Access Compliance Report Public Rights-of-Way (RR Crossings)

Intersection ID: 10025310	Main Street: E_5TH_ST	Location: N/A
ADA ID: F4683E334FEF	Overall Compliance: No	Severity Score: 0.0
Codes/Mitigation Info/Possible Solution		Field Measurements/Component Compliance

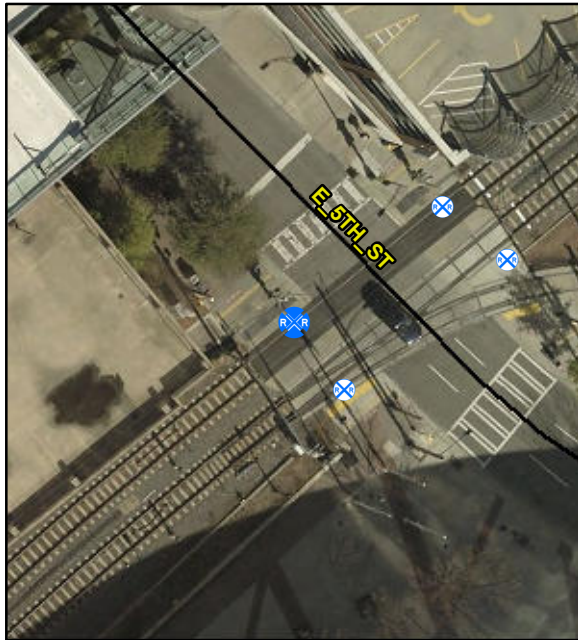
**Remove & Replace Detectable
Warning System. Provide Pedestrian
Gate.**

R305.2.5

Compliance	Description	Data
Yes	DWS Provided?	Yes
Yes	DWS Contrast?	Yes
Yes	DWS Width (in)	Yes
Yes	DWS Length (in)	36.0
No	DWS Offset (in)	25.0
No	Pedestrian Gate?	No
N/A	DWS Outside Gate?	N/A
N/A	Rail Type?	LightRail
Yes	Flangeway Gap (in)	2.0
Yes	Sidewalk Width (in)	212.0
